# 2014 - 2015 Corvette: Service Bulletin: Creak or Snap Noise Above Windshield from Removable Roof Lift Off Panel While Driving

**GM Bulletin No.:** #15-NA-016

**Date:** September 30, 2015

**SUBJECT:** Creak or Snap Noise Above Windshield from Removable Roof Lift Off Panel While Driving

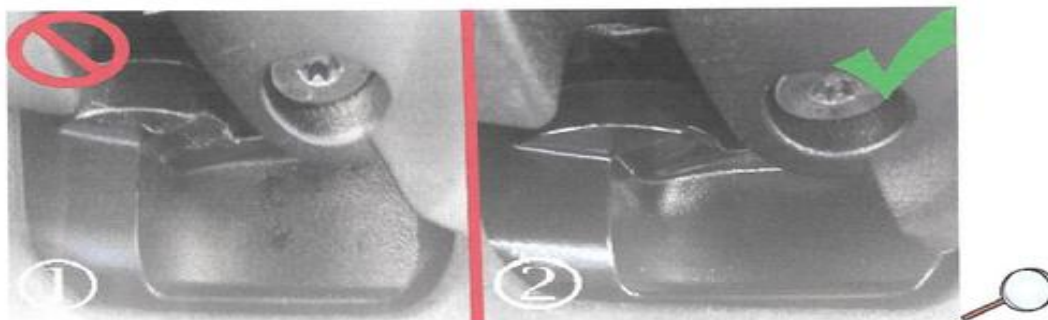
**CAUSE:** This may be caused by a stick-slip condition between the front latches against the strikers and the front locating pins to the locating cup in the strikers.

- (1) Example of a bad front locating pin.
- (2) Example of a good front locating pin.

- (1) Example of a bad striker.
- (2) Example of a good striker.

If you encounter a vehicle with the above concern, replace both the front roof lift off panel strikers and both front locating pins. Refer to Roof Lift Off Panel/Window Front Striker Replacement and Removable Top Locating Pin Replacement in SI.
